FIRE & LIFE SAFETY IMPROVEMENTS - 2014
EUGENE SCHOOL DISTRICT 4J
VARIOUS SITES
Eugene, Oregon
gLas Project No. 11041.14

ADDENDUM NUMBER ONE

April 24, 2014
Page 1 of 17

NEW CROSS HALLWAY DOOR (JAMB)		
	FIRE & LIFE SAFETY IMPROVEMENTS - 2014 EUGENE SCHOOL DISTRICT 4J	11041 4/17/14

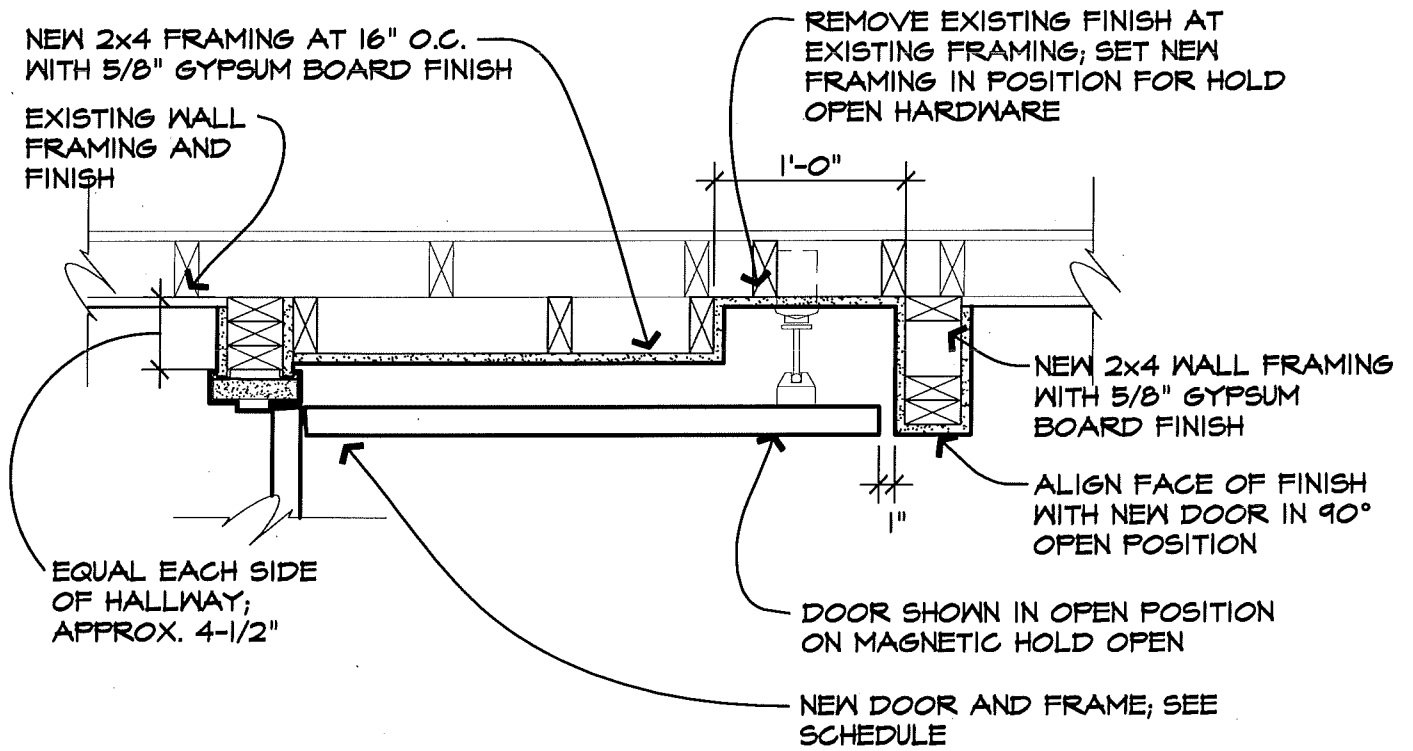
- 5) Details A/803, A/804 and Enlarged Plan Insert 10/A1:
 - a) Refer to these new details for the construction of a new set of cross-hallway set of doors at the hallway south of the stage at South Eugene High School.
 - b) Hardware shall be Group SE 10.
